Draft minutes of the 21st meeting of the CEVNI Expert Group

1. The CEVNI Expert Group held an extraordinary twenty-first meeting on 18–20 September 2013 at the invitation of the Central Commission for the Navigation of the Rhine (CCNR) at the Palais du Rhin in Strasbourg (France).

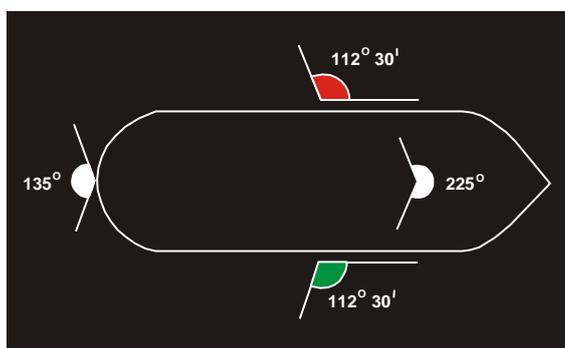
34. Amend annex 3, paragraph 1.2, as follows

1.2 The sketches **of this annex** are for guidance only; reference should be made to the text of the regulations which alone is authoritative.

36. Amend the caption under sketch 29 of annex 3 as follows

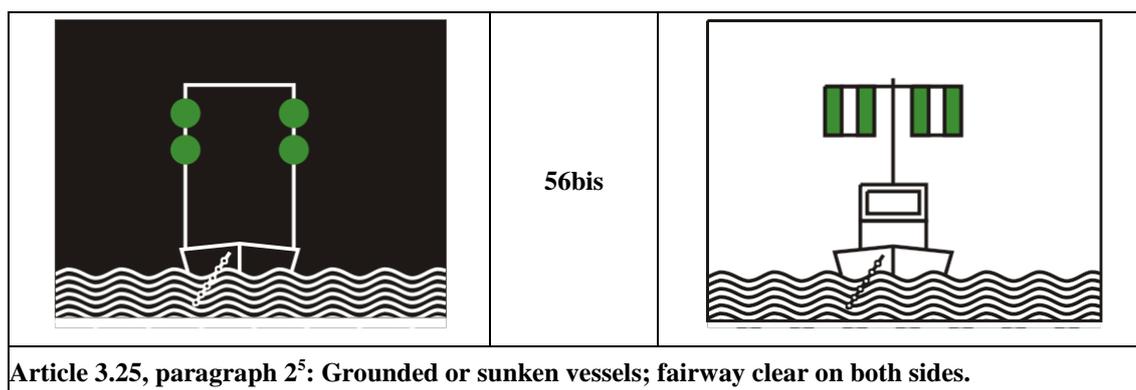
Article 3.13, paragraph 5: ~~Small~~ Sailing **small** craft less than 7 m long carrying a white light visible from all directions, and on the approach of other vessels displaying a second ordinary white light.

38. After sketch 57 of annex 3, add the following new sketches, corresponding to sketches 50a in RPNR:

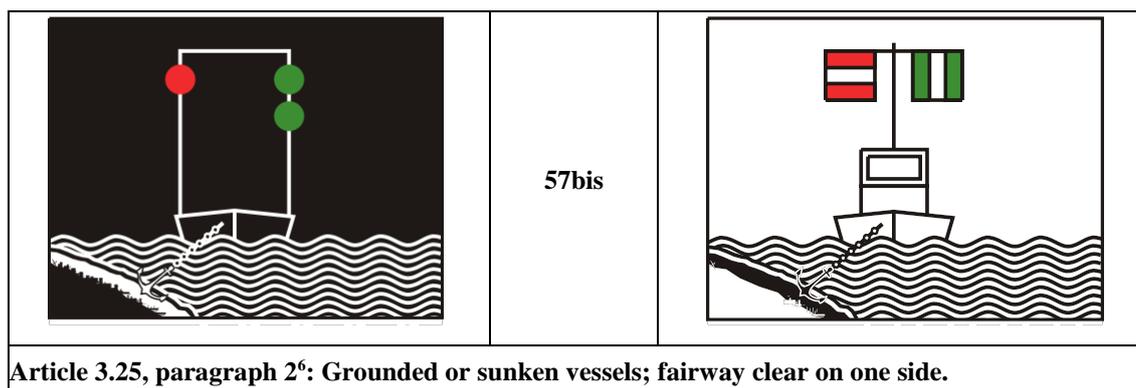
37. After sketch 56 of annex 3, add the following new sketches, corresponding to sketches 49a in RPNR:

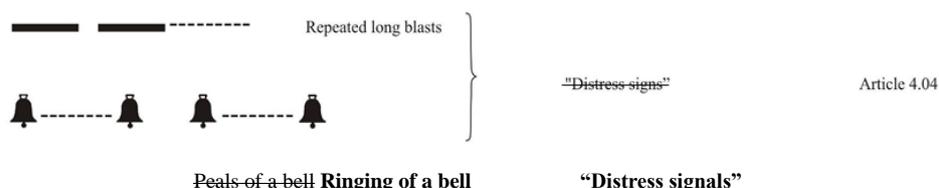
58. Reject the proposal to replace heading E.23 with the two signs under heading E.21 of RPNR.
